Re: Response to EPA Analysis of the *Final Habitat Mitigation and Monitoring Plan,* dated September 12, 2017, EPA Comments October 5, 2017 (Revised November 30, 2017) Rosemont Copper Project, Clean Water Act Section 404 Permit, CoE File No.: 2008-00816-MB

RESPONSE TO ENVIRONMENTAL PROTECTION AGENCY (2017)

"The Mitigation Proposed by Rosemont Mine Will Not Offset Impacts to Waters of the U.S. below the Level of Significant Degradation"

Project Number: 1049.117
January 24, 2018

Photo 1. Late 1930s View of Erosion Control Works along Sonoita Creek in the Vicinity of Rail-X Ranch

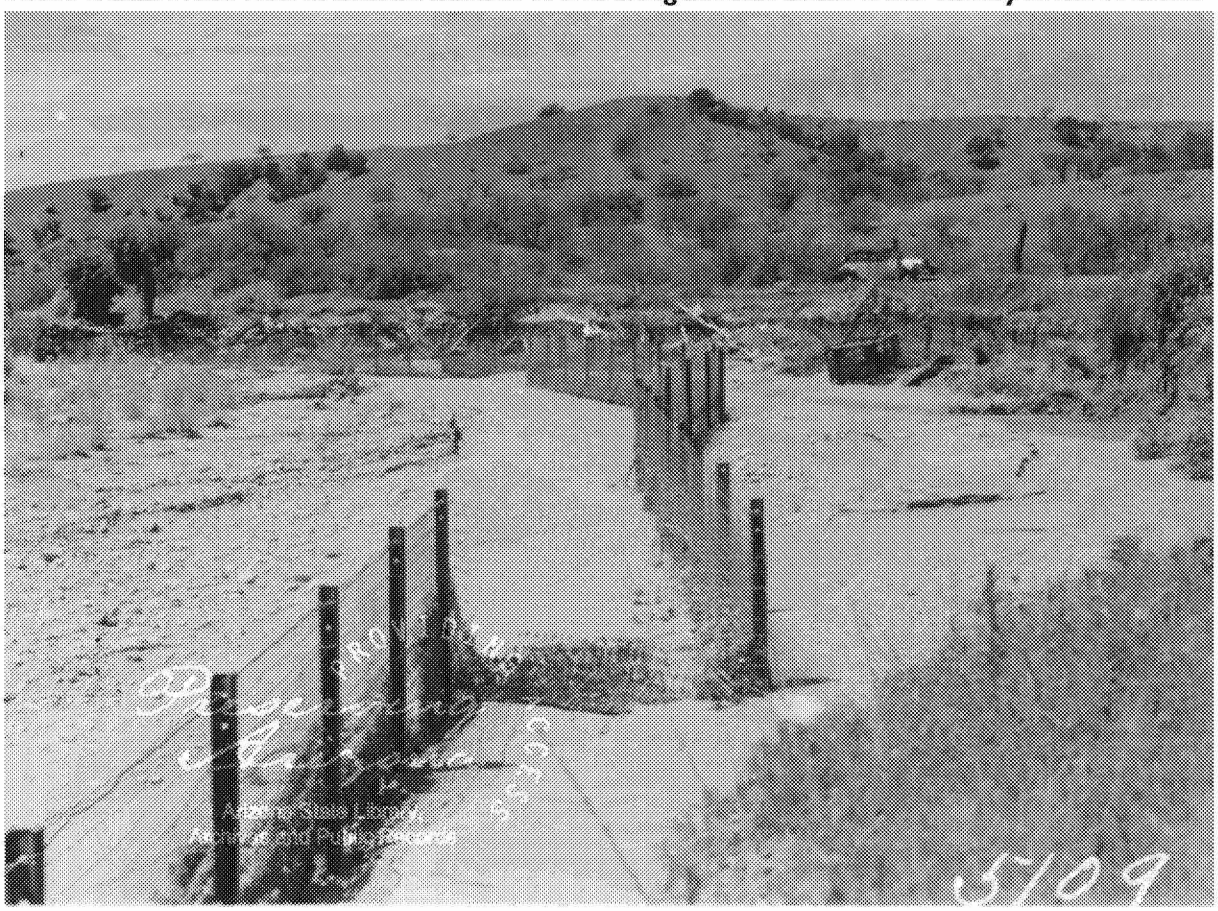
1. *Comment: The HMMP states:* The reestablished riparian floodplain system, including ephemeral channels and associated riparian habitat, have been designed to replicate, to the extent practicable, the form and function (gradient, sinuosity, composition, etc.) of the previous system that existed

Response: Here, the EPA (2017) provides a footnote reference to Kondolf and Ashby (2015), and a note regarding the supposed evidence provided by the review of a 1935 aerial photograph of the Sonoita Creek Ranch mitigation parcel. However, as noted in the discussion below, there is substantial evidence that the intense channelization of Sonoita Creek flows occurred as far back as the 1860's, or earlier.

As described previously, Anglo-American water management policies and practices lead to widespread downcutting along the Santa Cruz River, and there is evidence that similar changes had occurred along Sonoita Creek by the 1930s. A photograph believed to have been taken in the late 1930s in the vicinity of Rail-X Ranch shows that the stream had downcut and become incised by this point, and work was underway to construct gabions to reduce further erosion and protect State Route 82 (SR 82) (**Photo 1**). This shows that at least 60 years of Hispanic and Anglo-American water management practices had created an incised stream along this stretch of Sonoita Creek.

Taken together, these sources present strong evidence for Hispanic and Anglo-American modification of this stretch of the Sonoita Creek Valley going back, at a minimum, to 1869.

Figure 13. Walnut Gulch at Flume 6 and Downstream

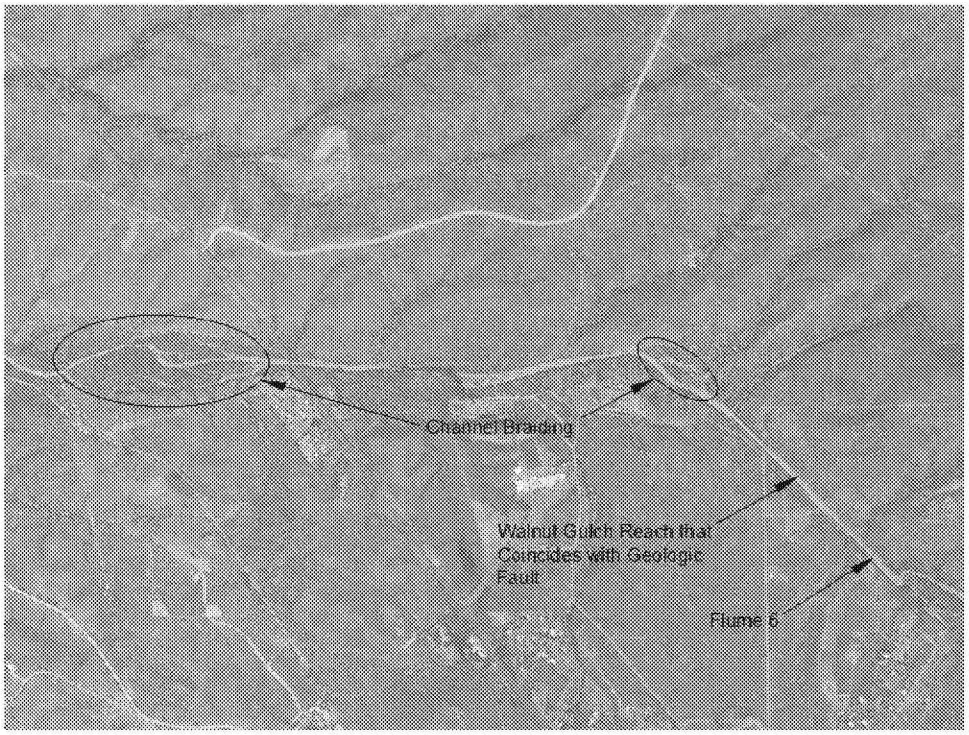
The EPA (2017) states that the HMMP (Exhibit 1) depicts Walnut Gulch from Flume 7 to Flume 1 and further states that Walnut Gulch does not exhibit any braiding patterns between Flume 6 and Flume 2, which demonstrates that Sonoita Creek will likely not exhibit any braiding patterns. The EPA also notes that the reach from Flume 7 to Flume 1 has significantly greater watershed area, tributary inputs, and channel dimensions than the upstream reach between Flume 2 and Flume 6.

The HMMP (Exhibit 1) depicts Walnut Gulch between Flume 2 and Flume 1 as well as downstream of Flume 1, and depicts a tributary to Walnut Gulch at Flume 7. The majority of channel braiding occurs along this reach of Walnut Gulch; this is not the same reach for which hydrologic analyses were conducted and results compared with recurrence intervals and peak flows from the SCR mitigation project. As described in more detail elsewhere, the reach near Flume 6 was identified as most like the SCR design watershed for hydrologic analysis, with its similar watershed area and elevation. However, the reach near Flume 6 at Walnut Gulch has important physical differences from the SCR mitigation project site. Specifically, Walnut Gulch near Flume 6 flows through a narrower valley with more physical constraints that limit channel migration and sinuosity more than the unconstrained physical conditions at Sonoita Creek. The straight reach of channel downstream of Flume 6 is coincident with a geological fault line and is confined by geologic controls, and therefore should not be used as a reference reach for sinuosity to apply to Sonoita Creek. Nevertheless, there is some braiding between Flume 2 and Flume 6 (**Figure 13**).

The occurrence of braiding along Walnut Gulch is more frequent where there is sufficient width of valley floor to accommodate multiple channels. This occurs to some degree downstream of Flume 6, but more significantly downstream of Flume 2, where relatively less confined reaches of Walnut Gulch are more physically similar to the conditions at Sonoita Creek (despite having a larger watershed area) than the reach near Flume 6. When analyzing channel form, the physical/geomorphological conditions in the reach from Flume 2 downstream to Flume 1 better represent Sonoita Creek than upstream at Flume 6, and are thus more representative of the channel form that is expected for the Sonoita Creek project area.

Figure 14. RX Ranch Agriculture Field and Leveled Topography

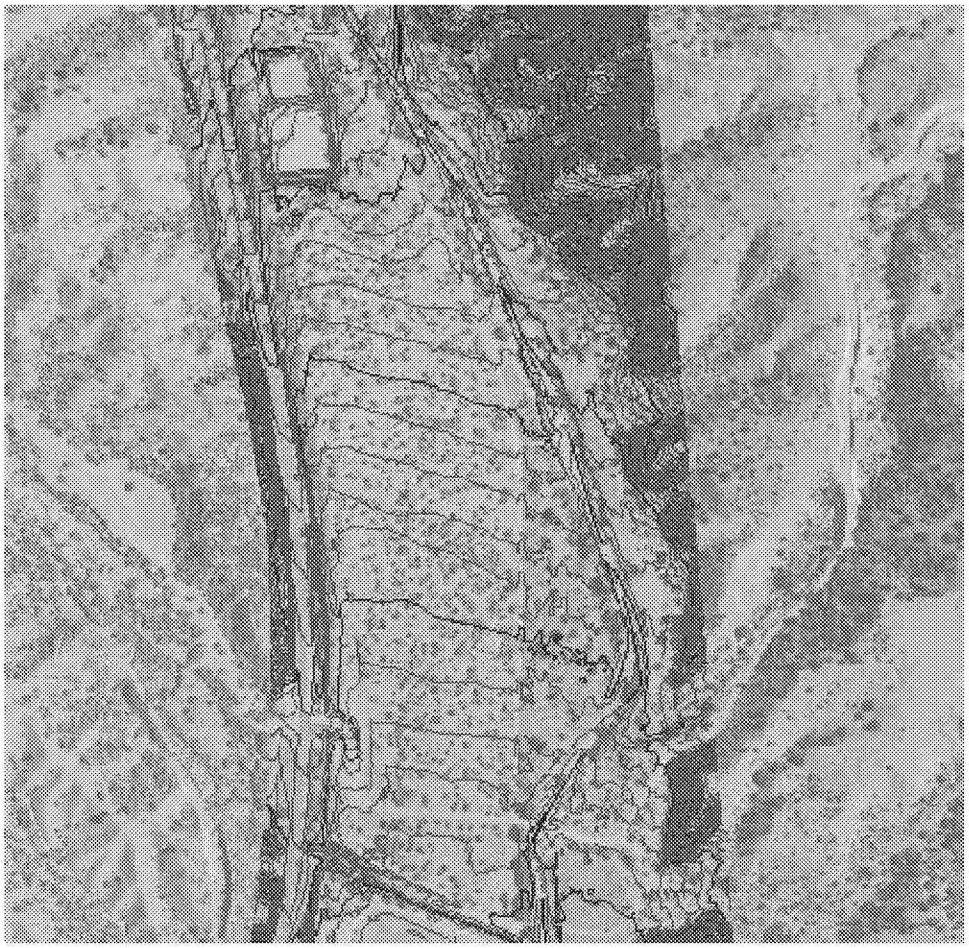
The EPA (2017) also argues that the proposed RX Channel was designed with excessively high sinuosity (1.15) to maximize mitigation credits, and implies that the high sinuosity is not sustainable.

At RX Ranch, clearly the valley bottom has undergone leveling activities and periodic cultivation. The parallel lines of topography at RX Ranch demonstrate the unnaturally uniform landform in this reach of the valley (**Figure 14**). There is considerable evidence of diversions and manipulation to Sonoita Creek at RX Ranch (**Section 2.3**). Currently, Sonoita Creek at RX Ranch is a straight reach with a single bend located on the east edge of the agricultural field. There is sufficient area within the agricultural field to reestablish Sonoita Creek and create a more sinuous, functional stream.

In response, we note that the sinuosity measured at Adobe Canyon is slightly higher than the proposed sinuosity of the RX Channel (**Figure 10**). EPA's sinuosity analysis included portions of Walnut Gulch between Flume 6 and Flume 2. However, it is inappropriate to include these portions of Walnut Gulch as reference reaches, as they are physically constrained and confined by local geology/topography and
